Browns Summit Creek Restoration Project Year 5 Monitoring Report

DMS Project ID No. 96313, DEQ Contract No. 5792

Subject: Response to Task 11 Draft Year 5 Monitoring Report Comments for Browns Summit
(DMS #96313) Cape Fear River Basin; CU 03030002; Guilford County, North
Carolina Contract No. 005792

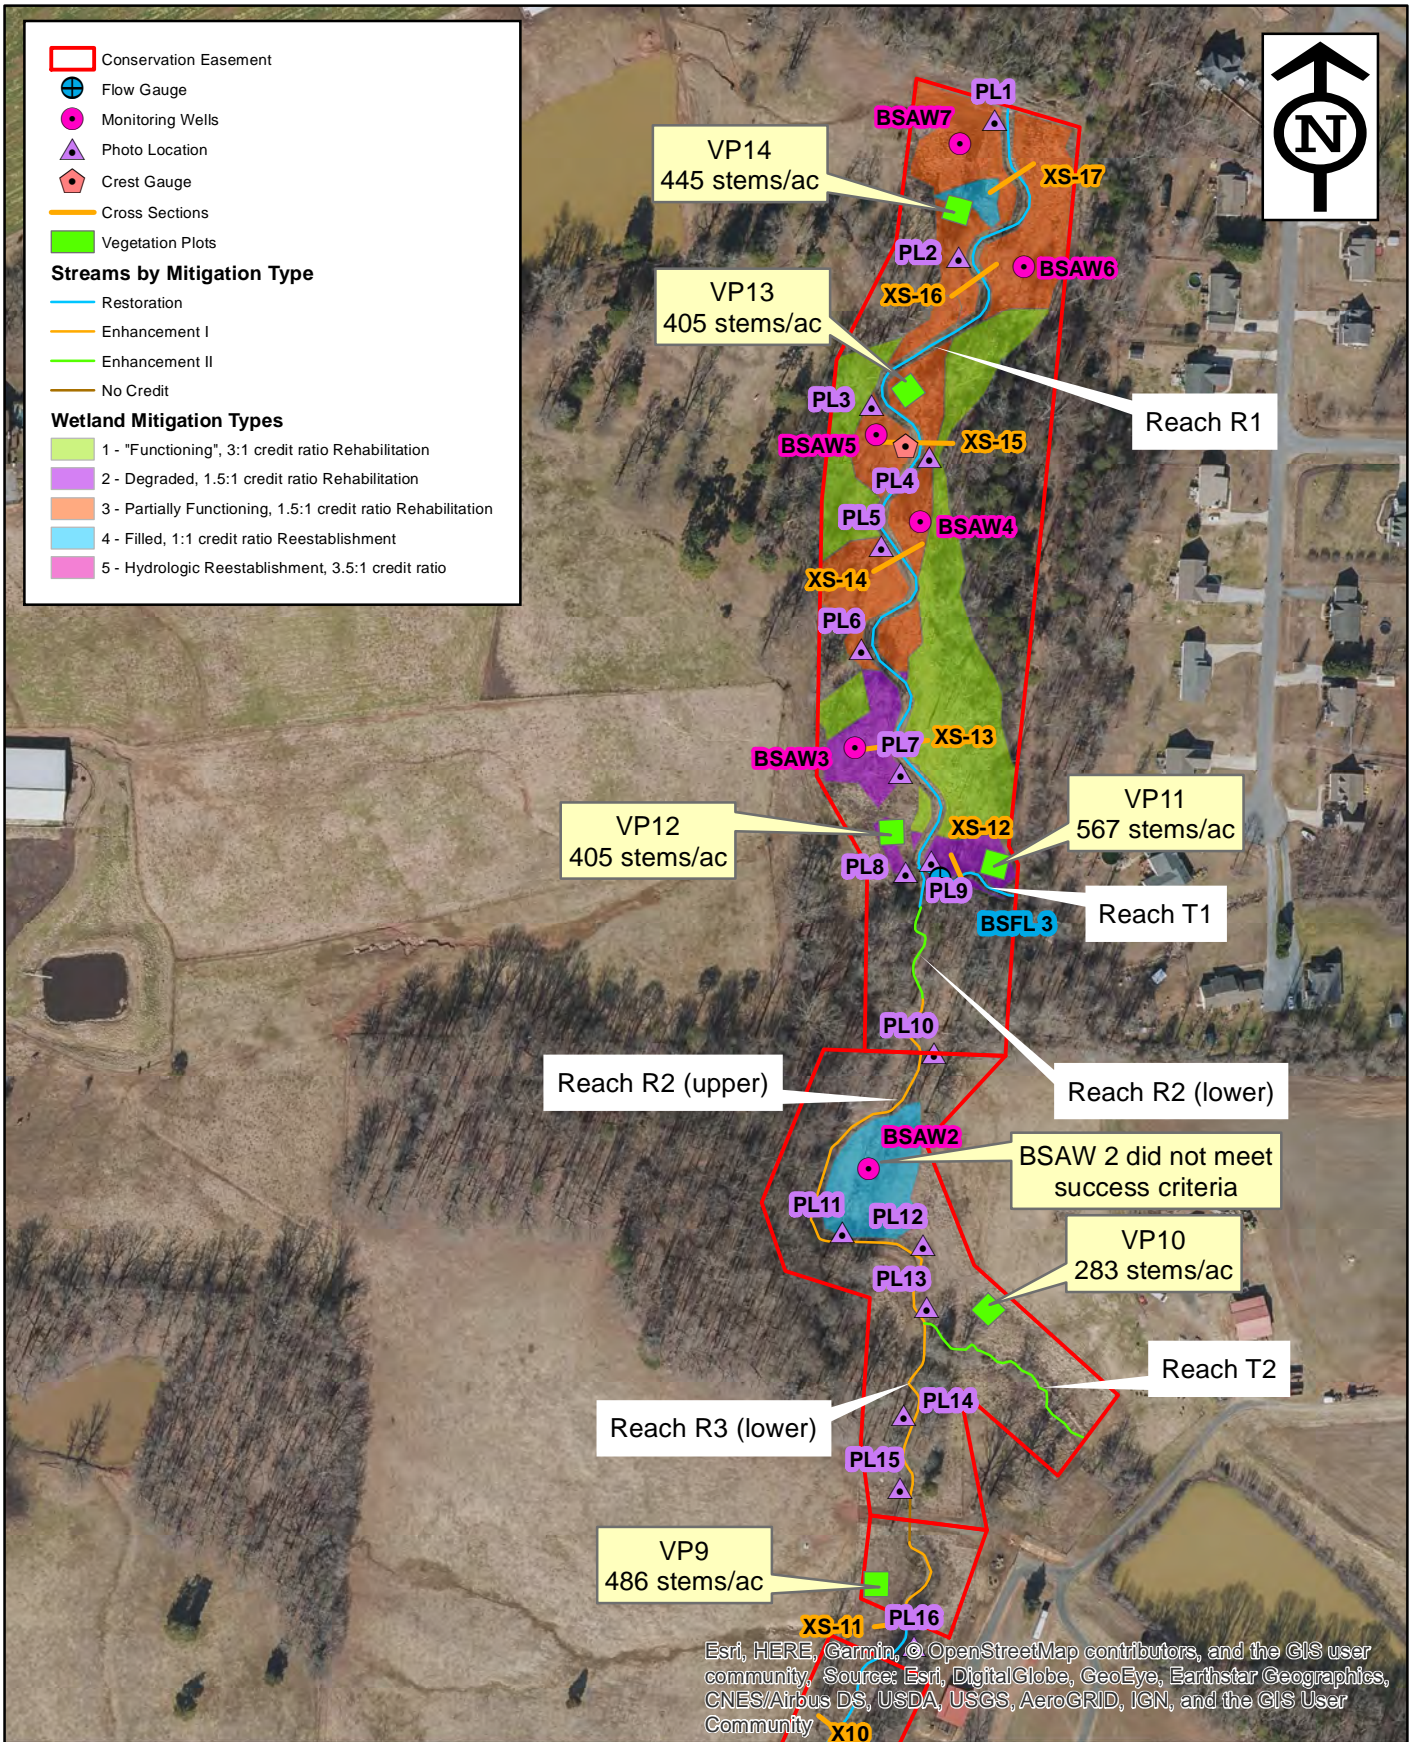
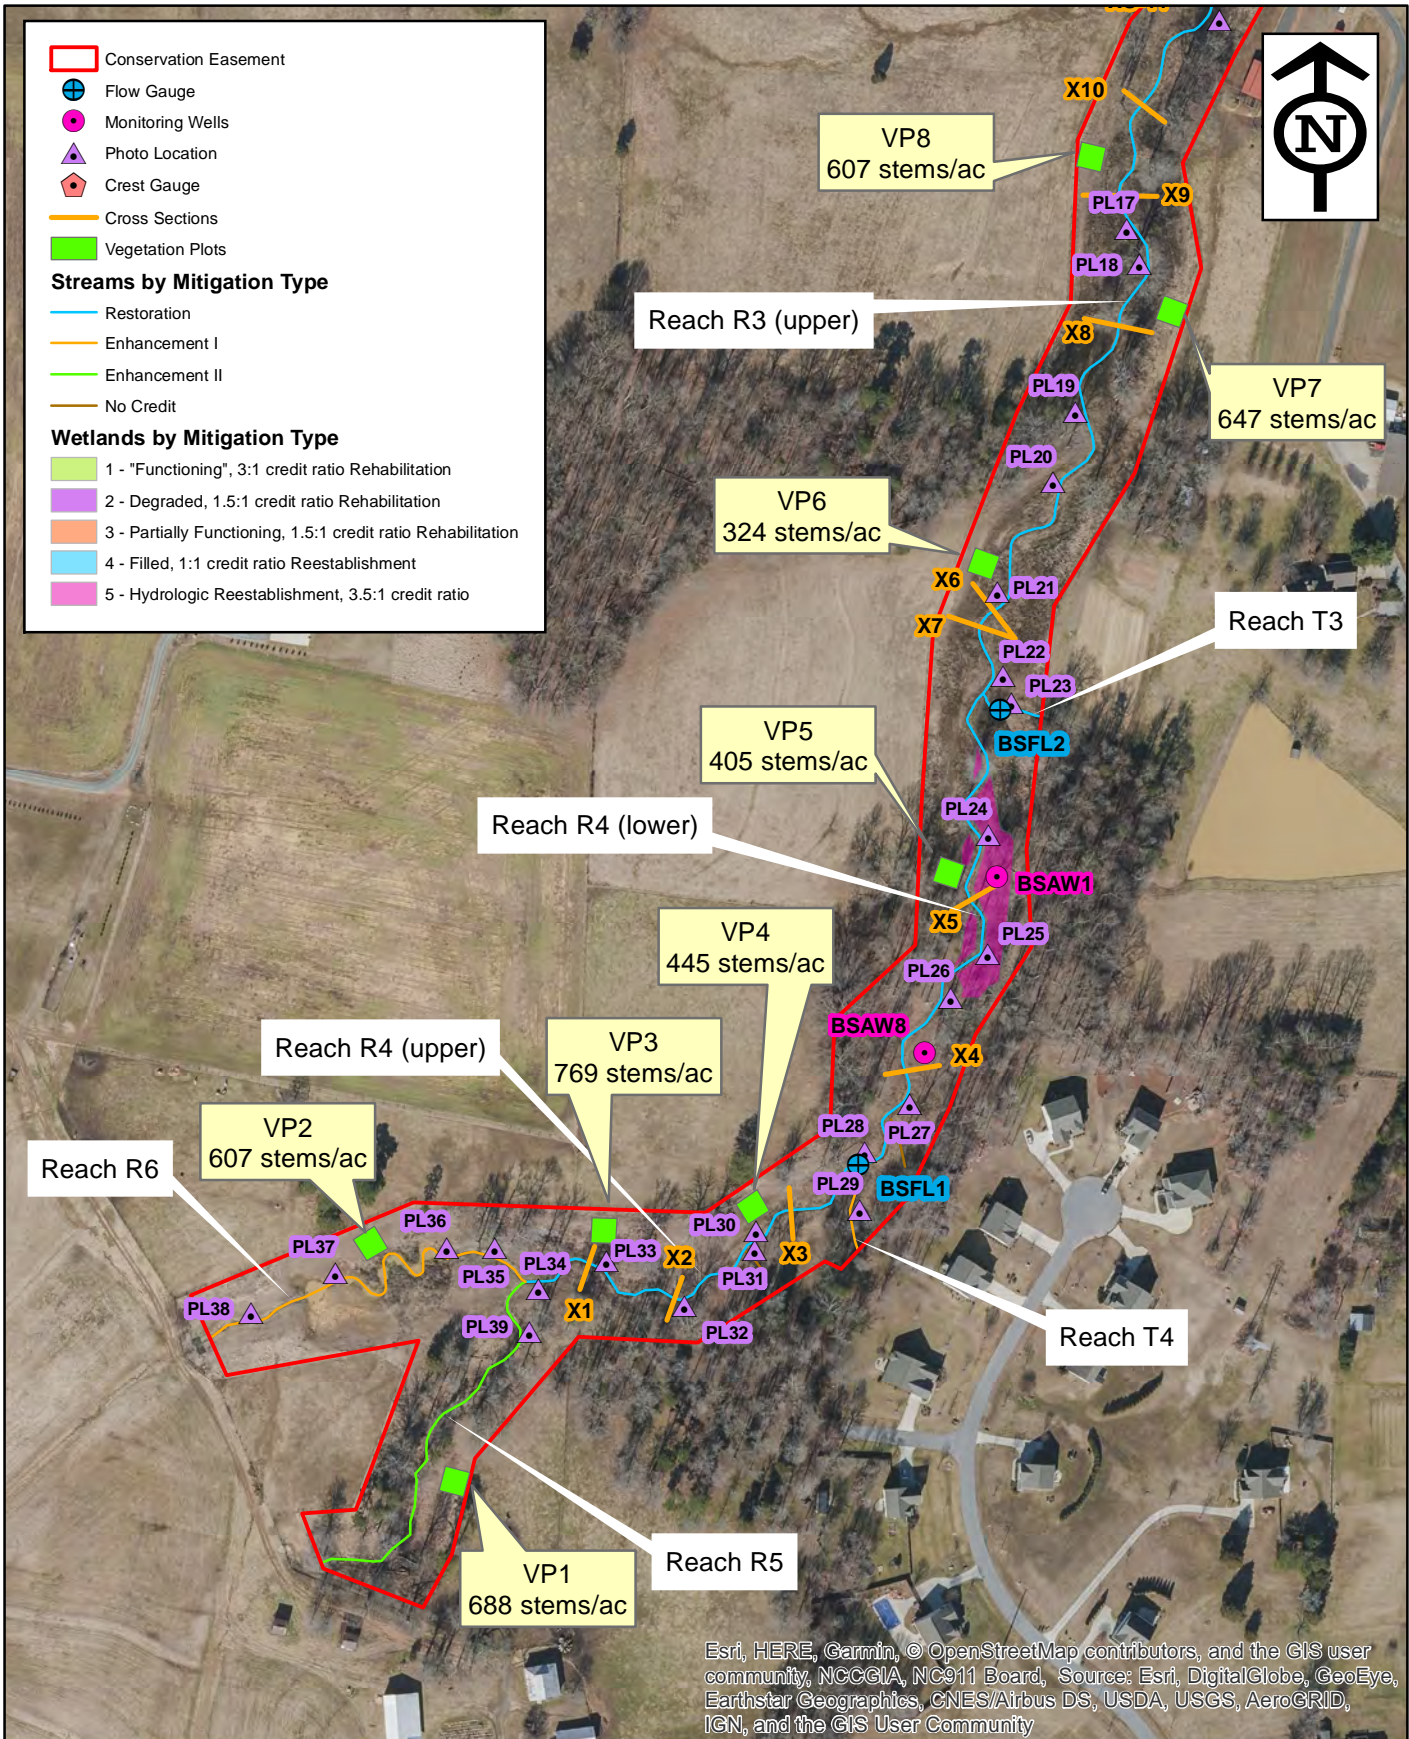
Comment: *Appendix A - CCPV:* Indicate the location of the Reach 2 structure of concern on the CCPV.

Response: Reach 2 grade control failed during MY3 but repaired in MY4. The CCPV has been updated to show no structures failing.

Figure 8. Observed Rainfall Versus Historic Averages

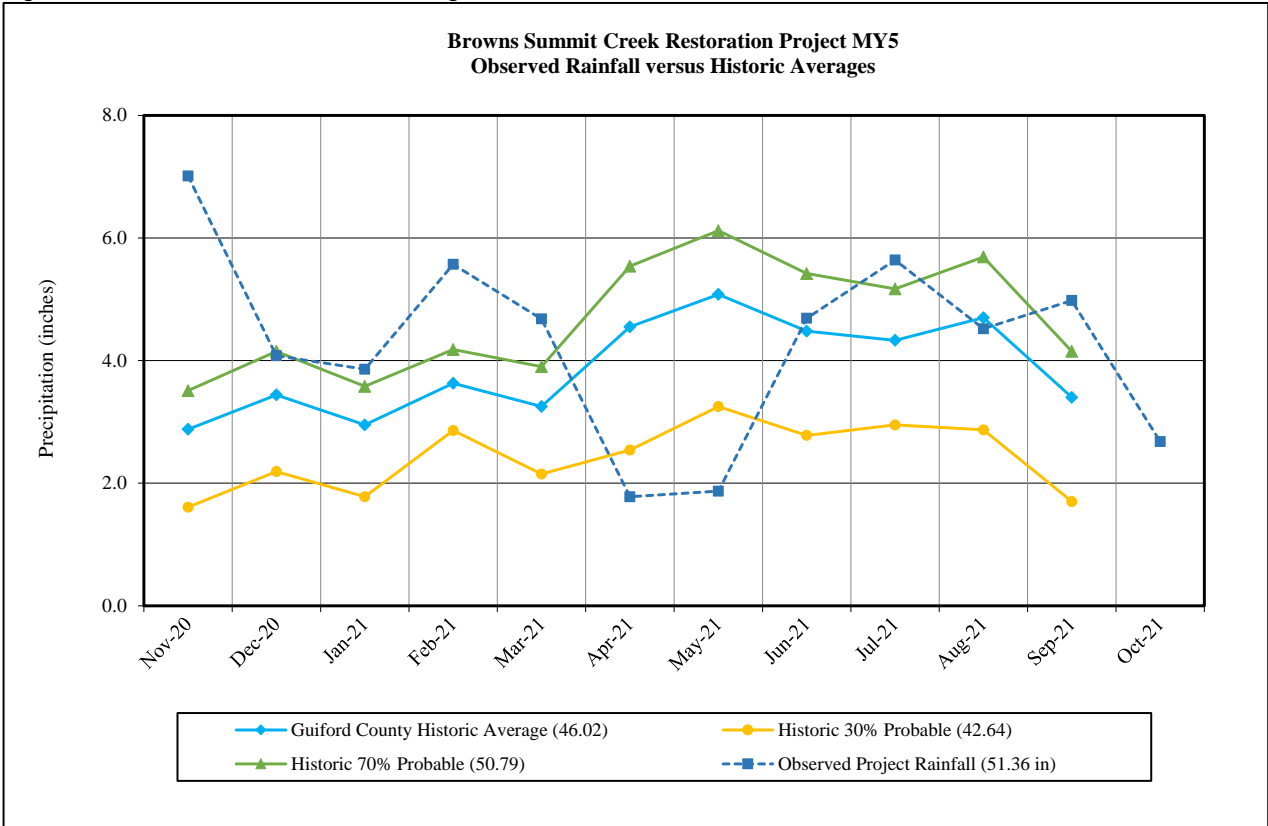
Comment: *Please include a figure or table that illustrates the 70th and 30th percentiles of monthly precipitation relative to observed monthly precipitation.*

Response: Figure 8. Observed Rainfall Versus Historic Averages has been included in Appendix E of the report along with the supported files located in the e-submission folder.
